CCC Interrogatory #063

Exhibit E1, Tab 1, Schedule 1, pp. 6-7

CCC Interrogatory #064

Chart 1
Niagara River Flows – Actual & Forecast (2020-2027)

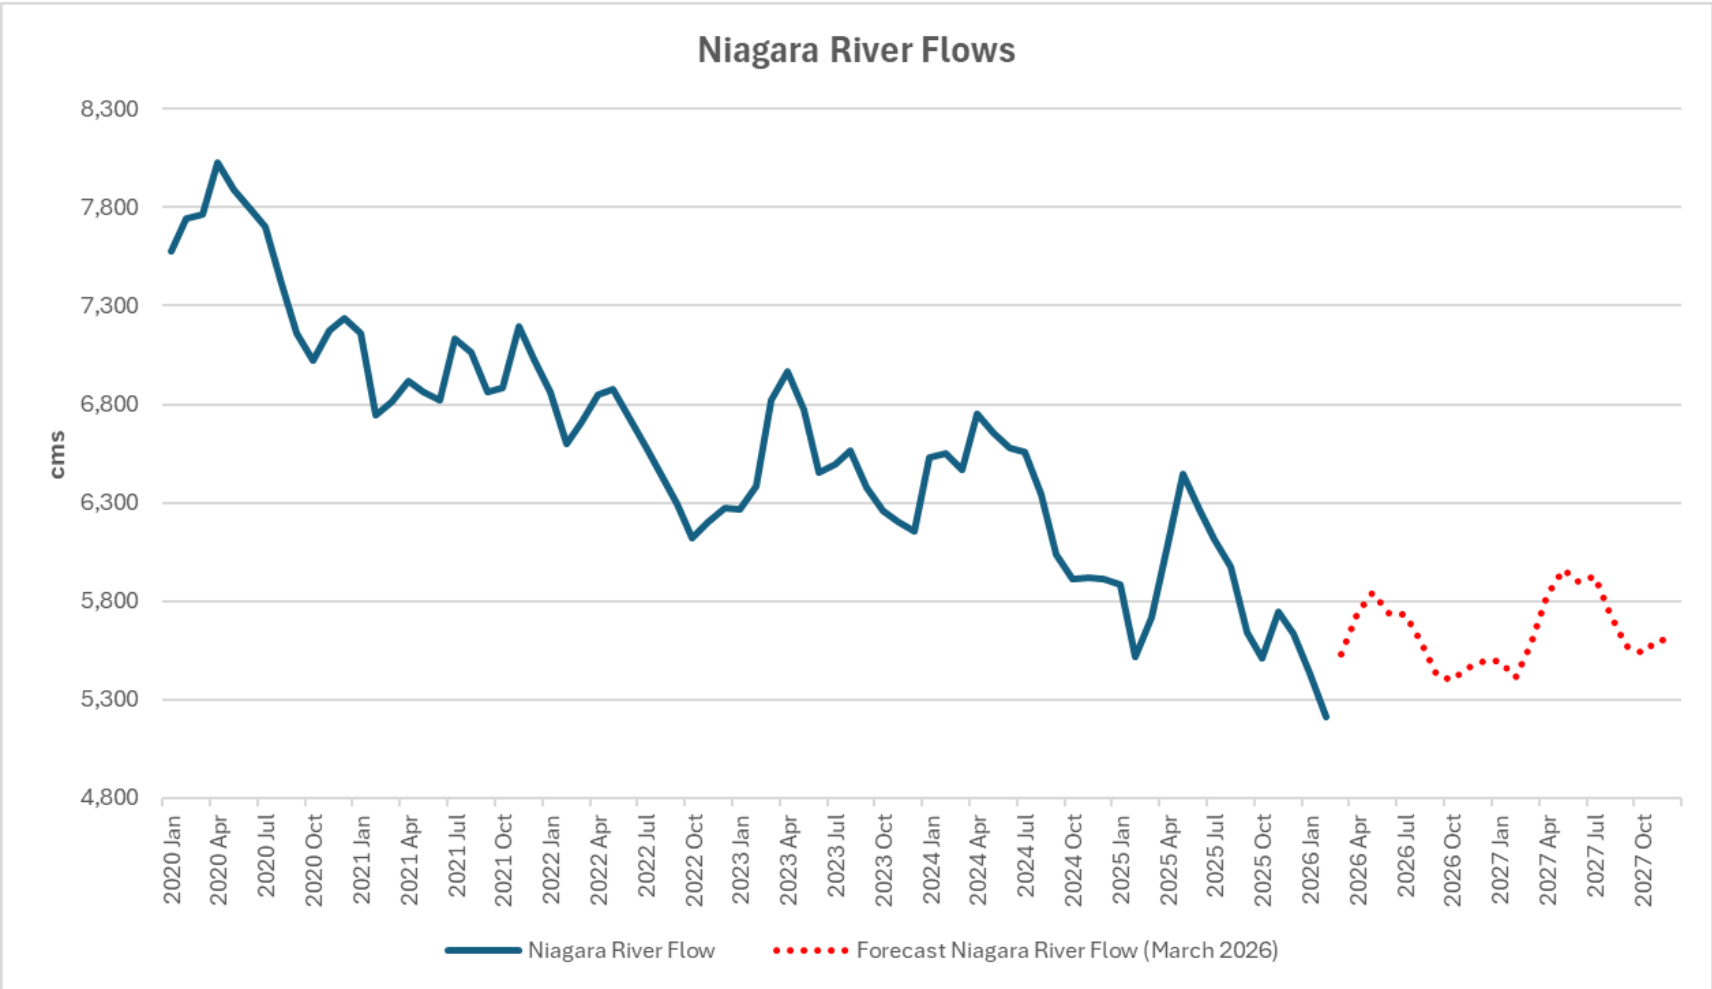
- v) For hours where the PGS pump is not running at full capacity despite SBG conditions, a listing of all the reasons why that is not the case.
- b) OPG states: “OPG attributes the increase in PGS utilization and the concomitant decline in hours with SBGVA bookings when the PGS is not pumping to the absence of very high flows on the Niagara river and sufficient price spread in the market.” Please provide a table of data to illustrate the change in flows and a forecast of the same data over the next five years. Please also provide a qualitative response regarding the expected flows in the coming years.

20 The Niagara River experienced a period of higher-than-average flows from 2017 to
21 2023. The high flows peaked in 2020 and then began to return to the long-term
22 average. At the time of this response, Niagara River flows are below long-term
23 average. The 2027 test year Niagara River production forecast is based on long-
24 term average flows.

At Reference 2, OPG provided a table that sets out “SBG Spill Booked to SBGVA (MWh)” on a monthly basis, for 2021 – 2025.

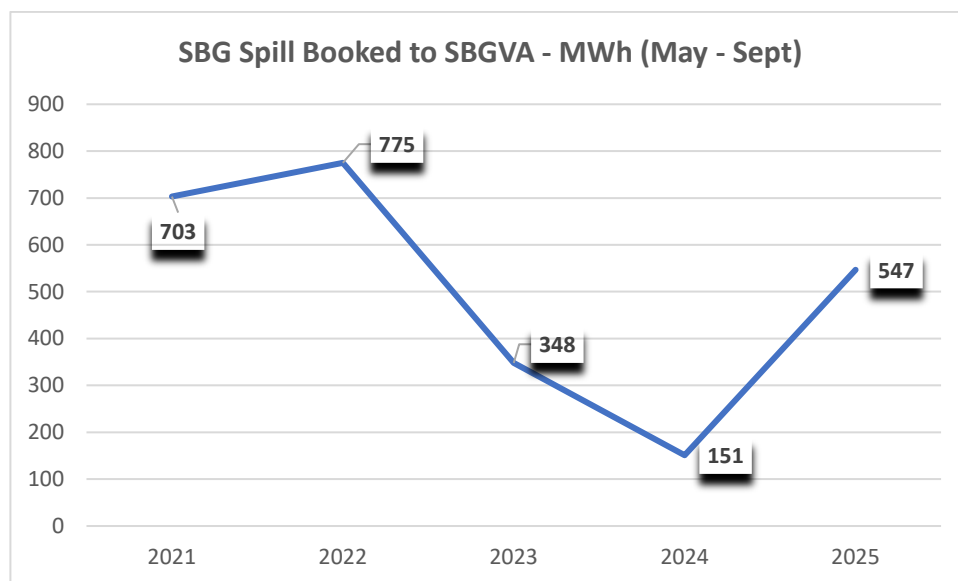
OEB staff focused on comparing the same subset of months that Surplus Baseload Generation (SBG) spill data was provided by OPG for the Renewed Market (May to September) across all the years. That is reflected in the chart below which shows the amount of SBG spill booked to the Surplus Baseload Generation Variance Account (SBGVA) declining substantially in the years before Market Rate Program (MRP) was implemented – from 2021 & 2022 (both years over 700 MWh) to 2024 (151 MWh). In the months following MRP Go-Live, it then increased considerably (547 MWh).
